ADDENDUM NUMBER: One (1)

DATE: November 12, 2025

PROJECT: MONTGOMERY COUNTY EMS STATION 28

DESIGNER: DOUGLAS A. JONES, ARCHITECT
MONTGOMERY COUNTY ENGINEERING

C6.0

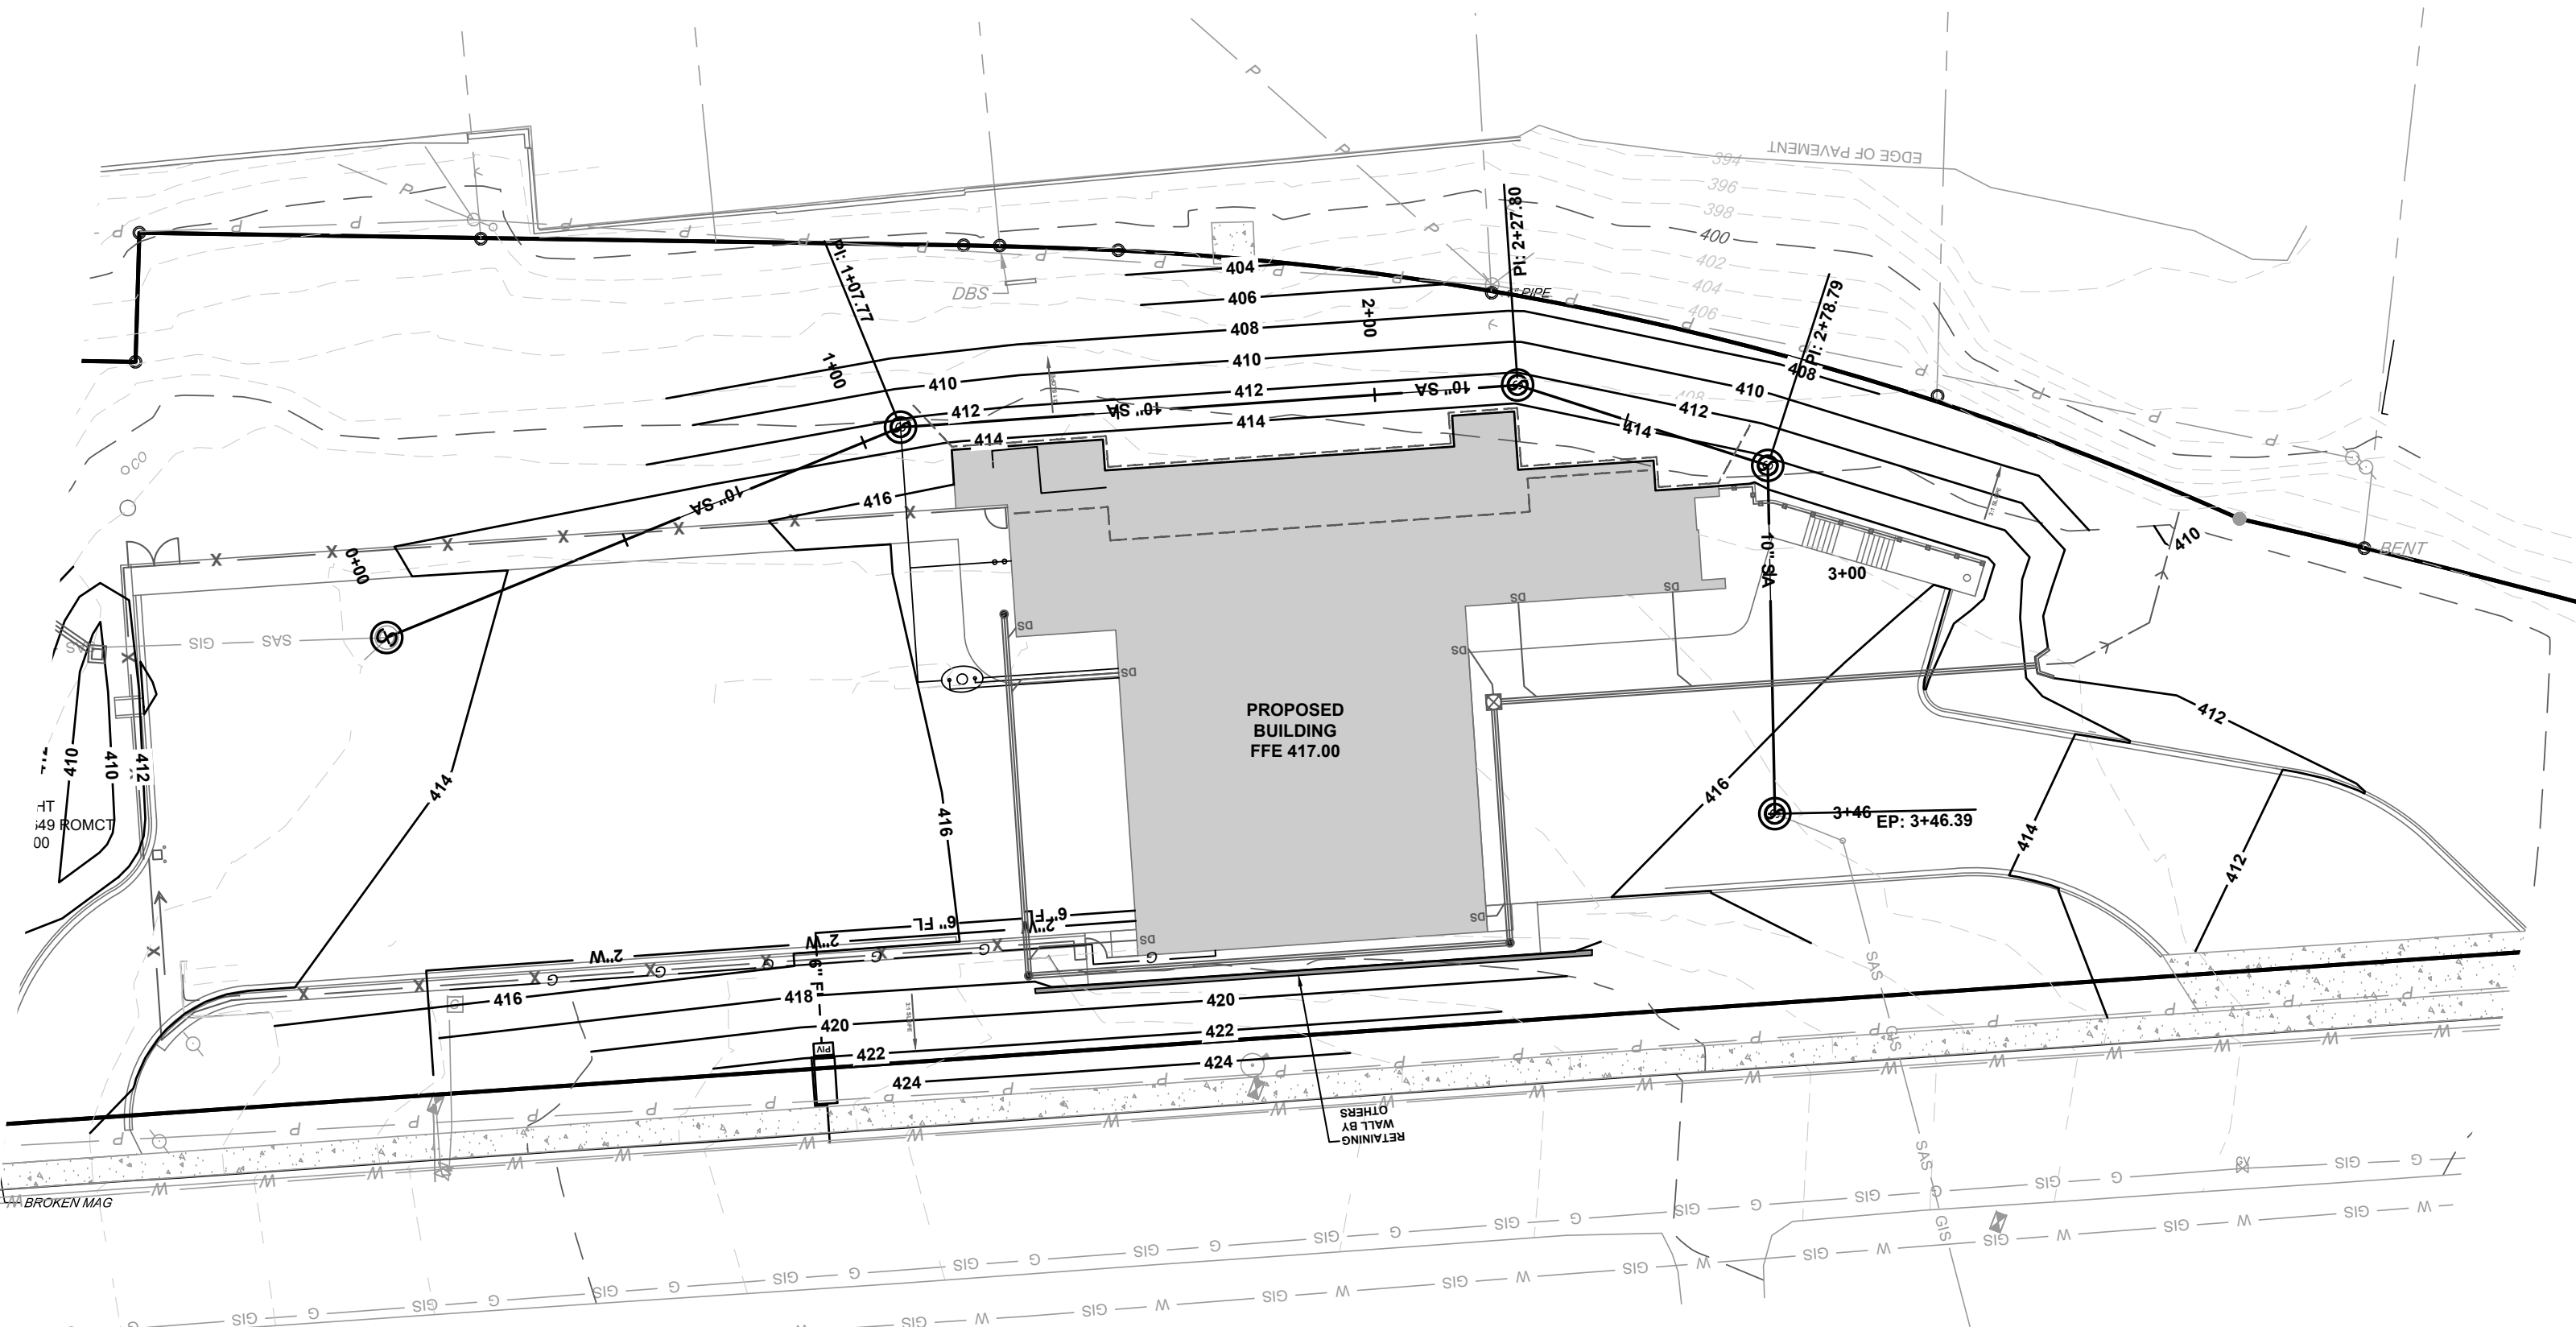
SHEET C6.0 - UTILITY PLAN; Delete Sheet C6.0 dated 11/03/2025 in its entirety. Substitute therefor: Sheet C6.0 - UTILITY PLAN dated 11/12/2025 attached hereto.

Clarification: Added note regarding location of existing sewer service line to remain. Add note regarding tie into existing 2-inch water meter.

C6.1

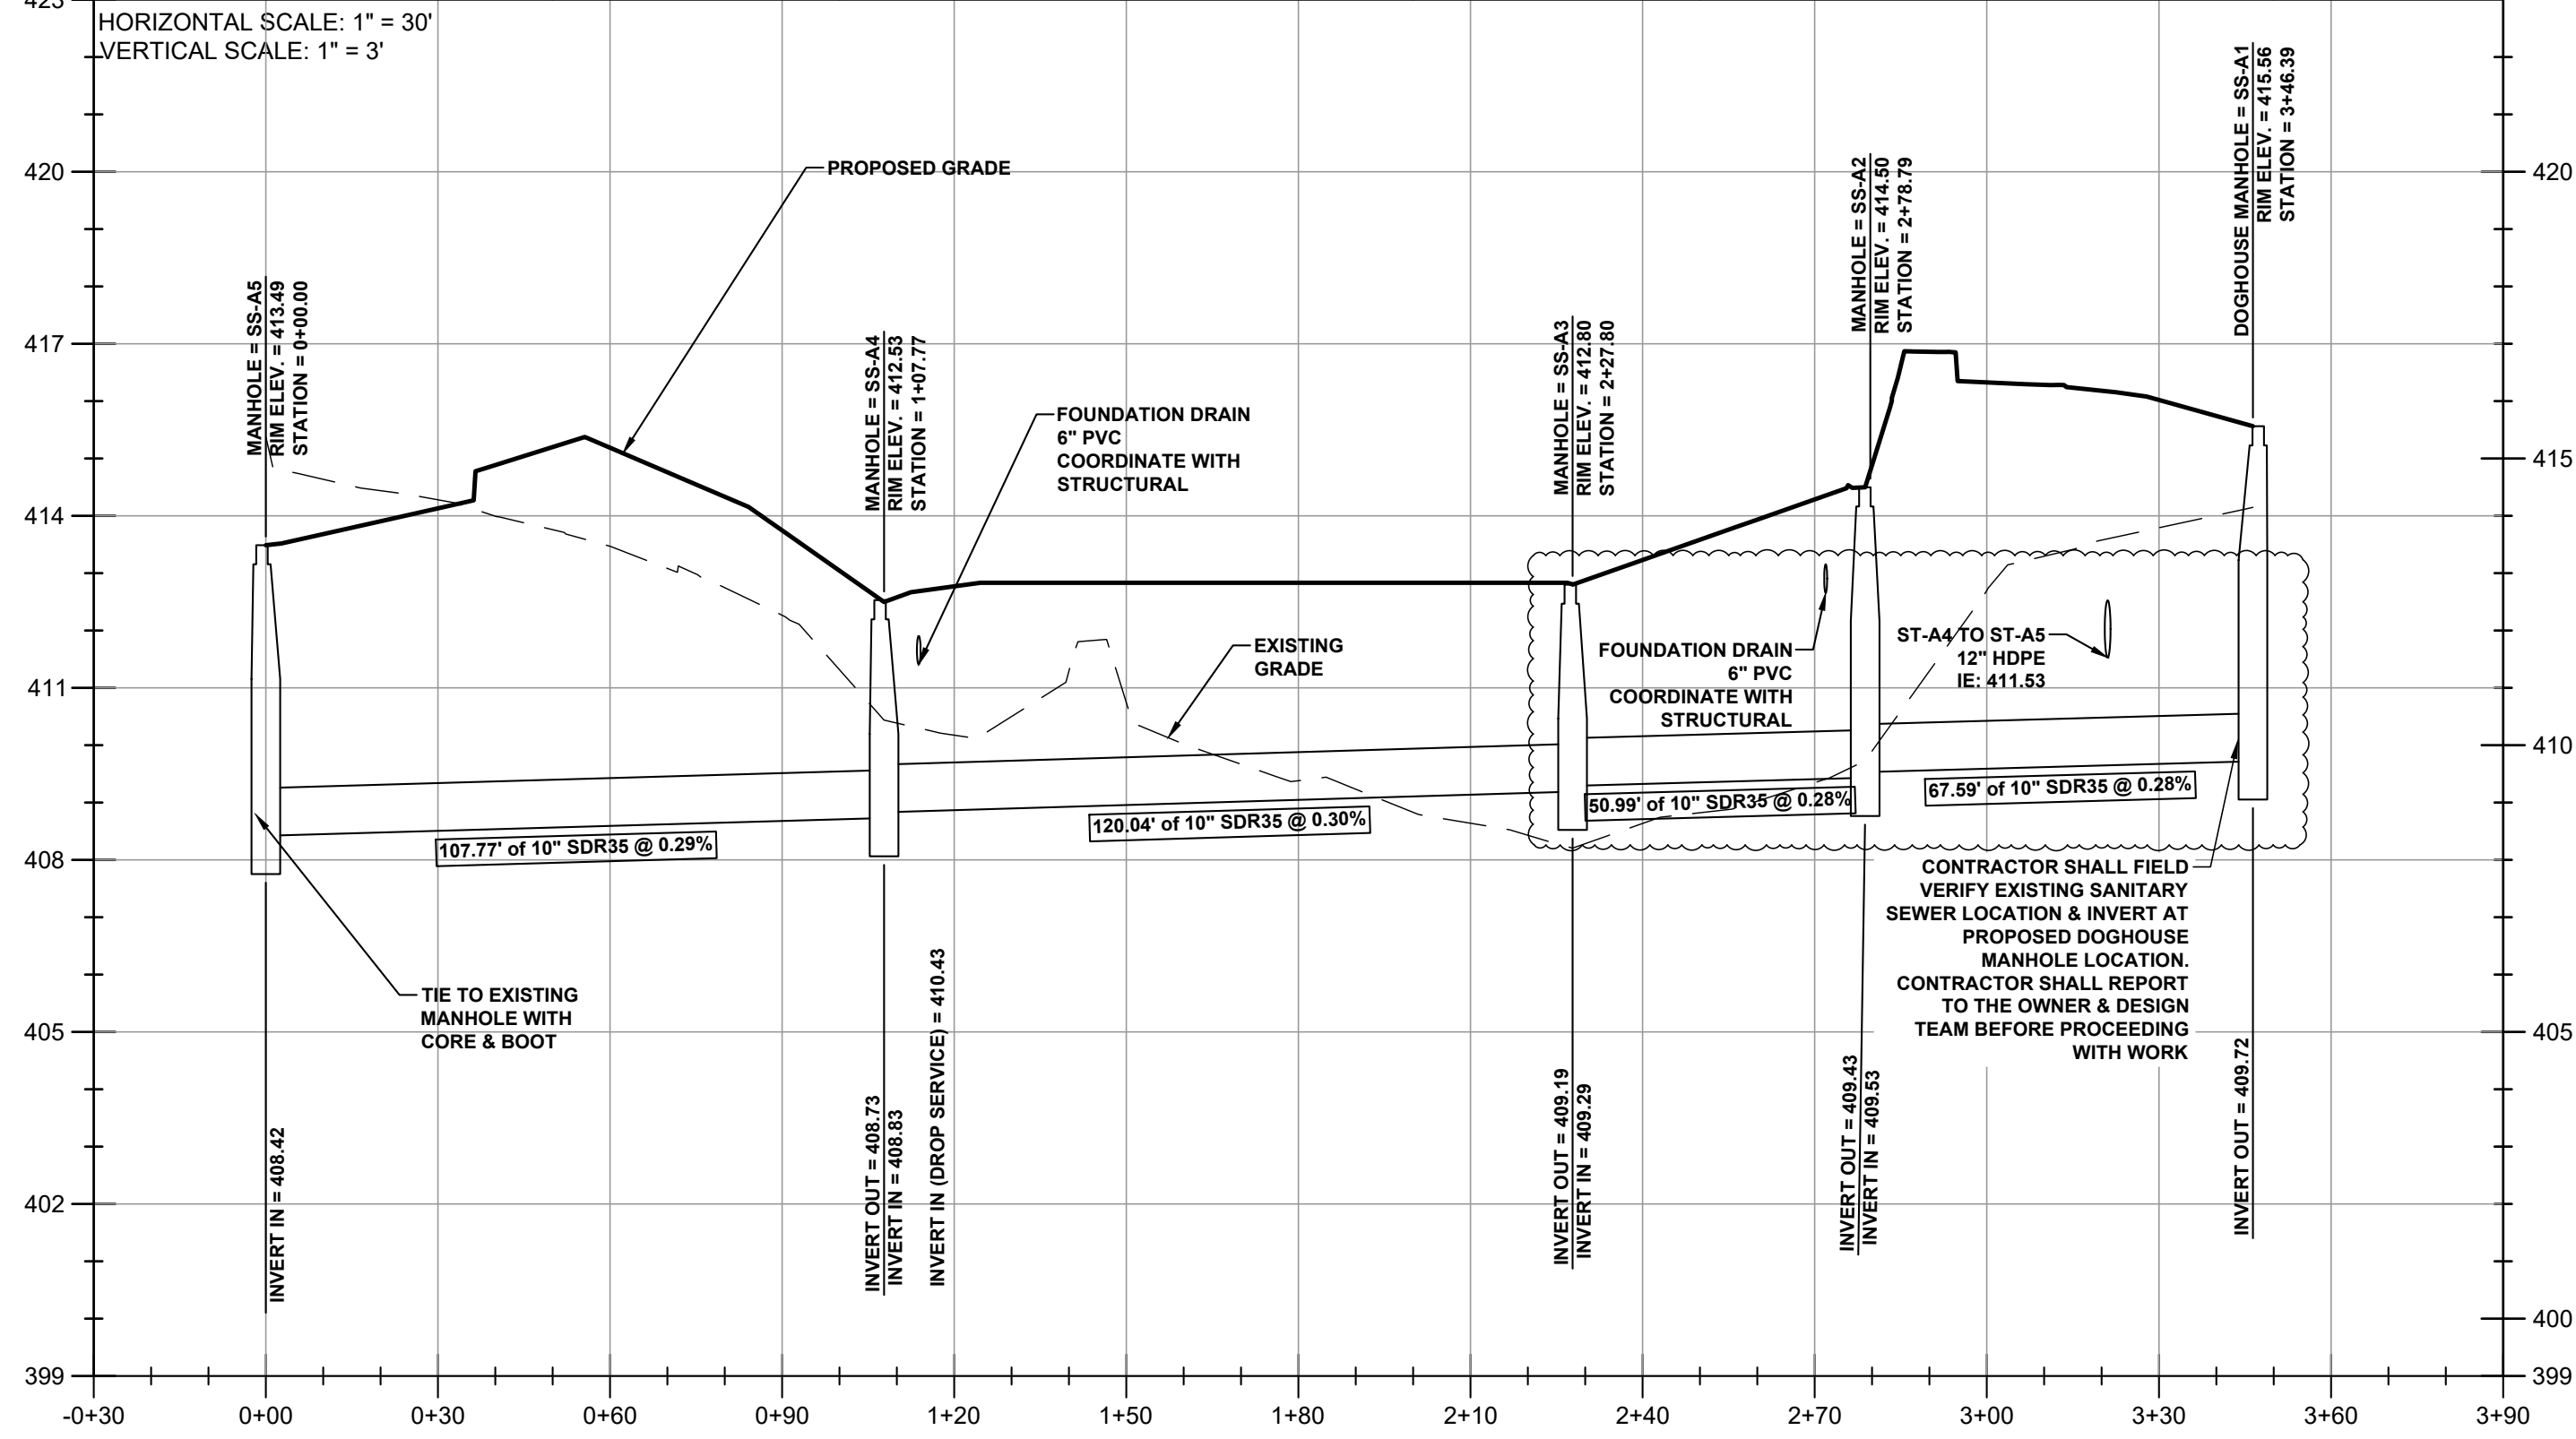
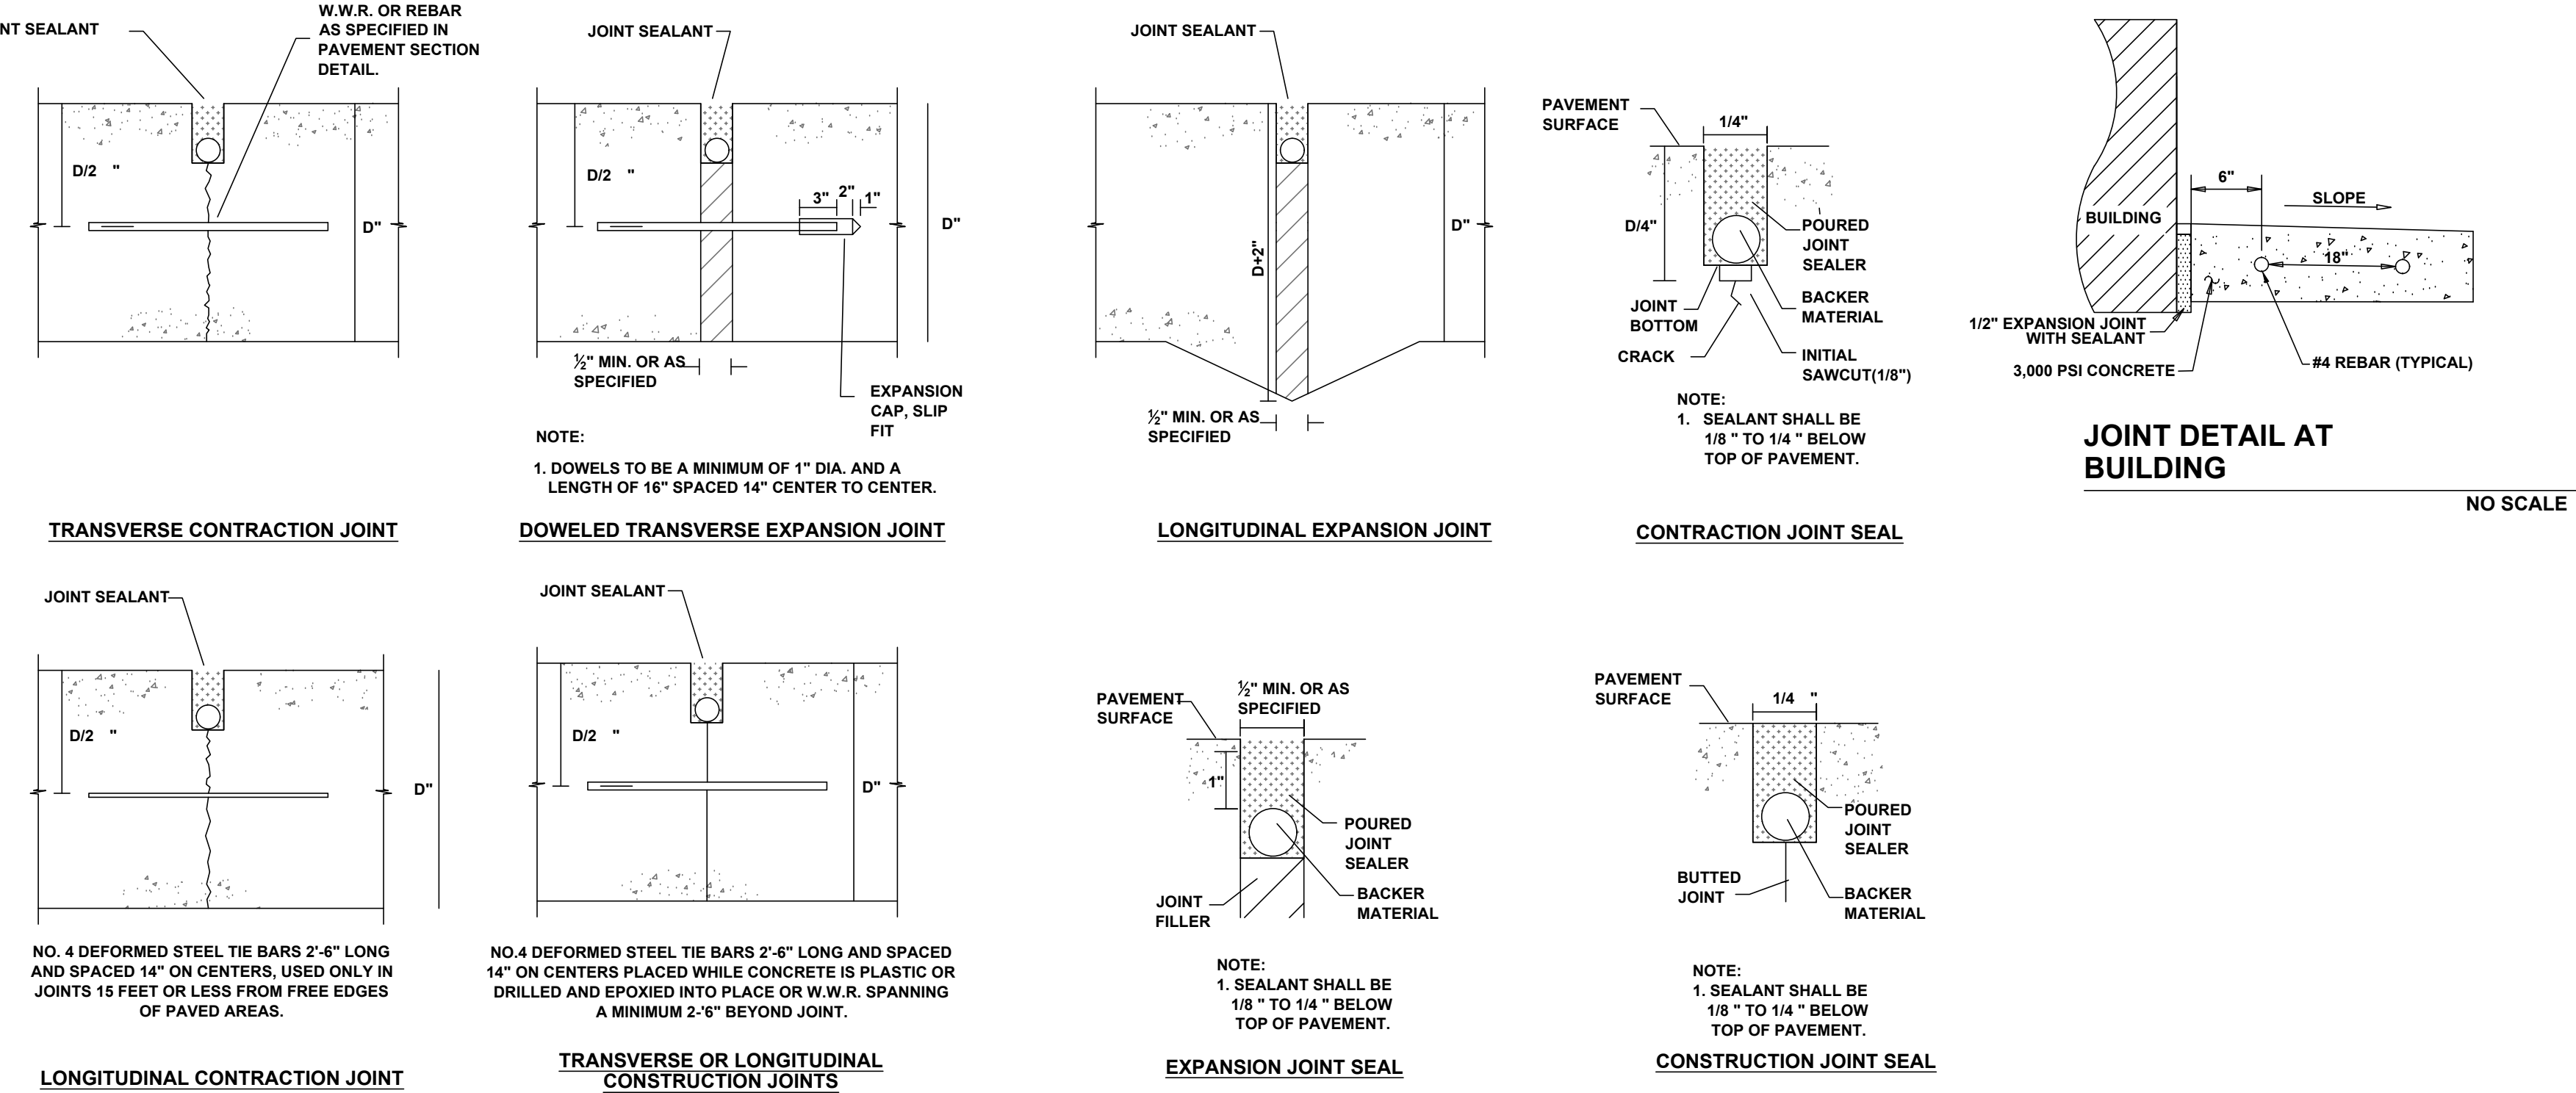
SHEET C6.1 - SANITARY SEWER PLAN & PROFILE; Delete Sheet C6.1 dated 11/03/2025 in its entirety. Substitute therefor: Sheet C6.1 - SANITARY SEWER PLAN & PROFILE dated 11/12/2025 attached hereto.

Clarification: Changed slope of sanitary line to meet slope requirements for 10-inch line.
